**STATE SIGNIFICANT DEVELOPMENT
ASSESSMENT**
***Mount Owen Continued Operations
Project (SSD 5850)***

Final Assessment Report
Section 89E of the
Environmental Planning and Assessment Act 1979
October 2016

FIGURE 4.1
Updated Mount Owen
Biodiversity Offset Strategy

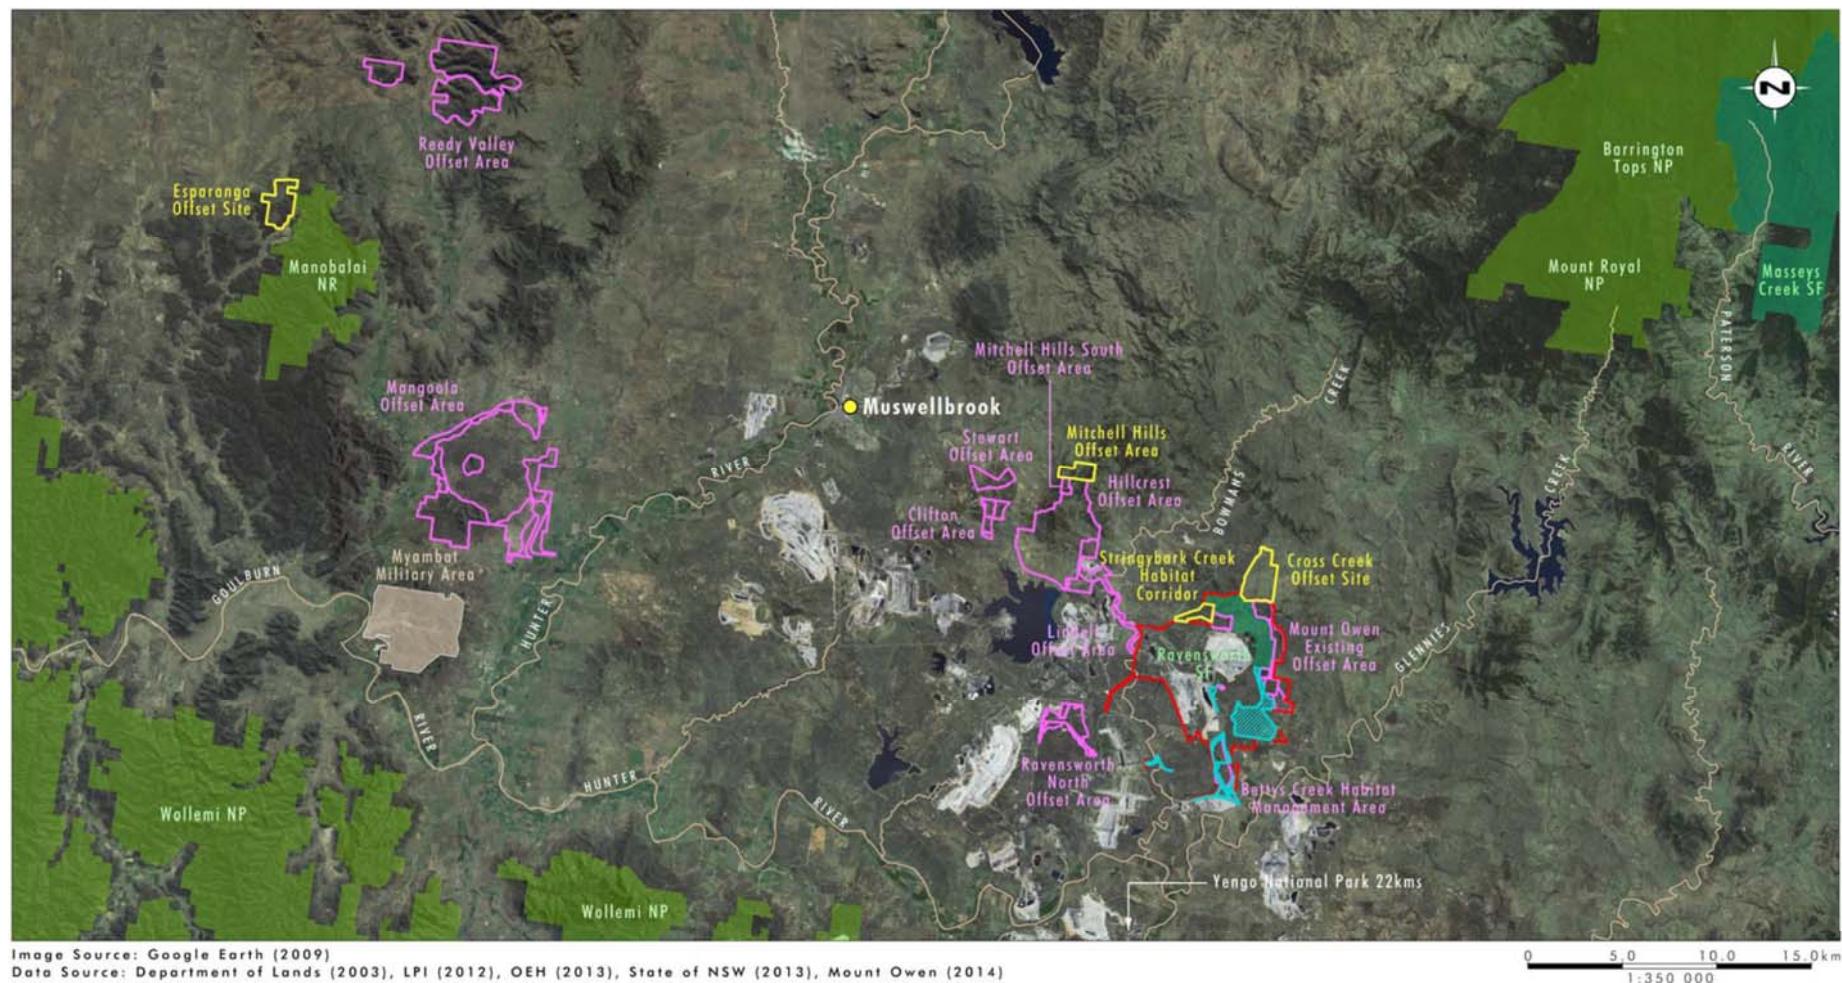
Glencore's response to the Commission's Review Report included the offer of an additional 144 ha biodiversity offset, known as the Mitchell Hills Offset Area. This additional offset is located close to the project and borders Glencore's existing Hillcrest and Mitchell Hills South Offset Areas. OEH supported this additional proposed offset, noting that it strengthens the offset package provided for the project. OEH also identified that the Mitchell Hills Offset Area contains remnant woodland, as well as likely habitat and movement corridors for the Spotted-tailed Quoll.

The Department notes the strategic location of this additional offset, which adjoins the existing network of Glencore offsets in the Greater Ravensworth area (see **Figure 1**). It would strengthen this network of wooded vegetation corridors and promote the movement of threatened fauna in the region. This proposed offset is comprised mainly of established woodland and forest communities, including 83 ha of *Barrington Footslopes Dry Spotted Gum Forest*, dominated by *Corymbia maculate*, which is a key winter-flowering foraging species for Swift Parrots and Regent Honeyeaters. The area also contains known habitat for threatened micro-bat and mammal species, including the Large-eared Pied Bat, Eastern Bent-wing Bat, Spotted-tailed Quoll and Brush-tailed Phascogale.

Given this additional offset area, removal of the proposed RERR pit and changes to the final landform and rehabilitation plans, the Department has reviewed the offset ratios for the project. The offsets package would still only provide upfront like-for-like offsets of 0.3:1 for the *Central Hunter Ironbark – Spotted Gum – Grey Box Forest Endangered Ecological Community* (EEC). However, it is expected that this offsets ratio would increase to 2.6:1 following regeneration of Derived Native Grassland (DNG) within the offset sites. OEH has supported the fact that regeneration of cleared land with intact soil profiles and seed banks (ie DNG) can support the re-establishment of previous woody plant communities. The Department is therefore satisfied that, with the proposed management measures and supplementary planting of underrepresented species, the proposed biodiversity offset package provides an adequate offset for this EEC and meets the requirements of the applicable *Interim Policy on Assessing and Offsetting Biodiversity Impacts* (2011) (the Interim Policy).
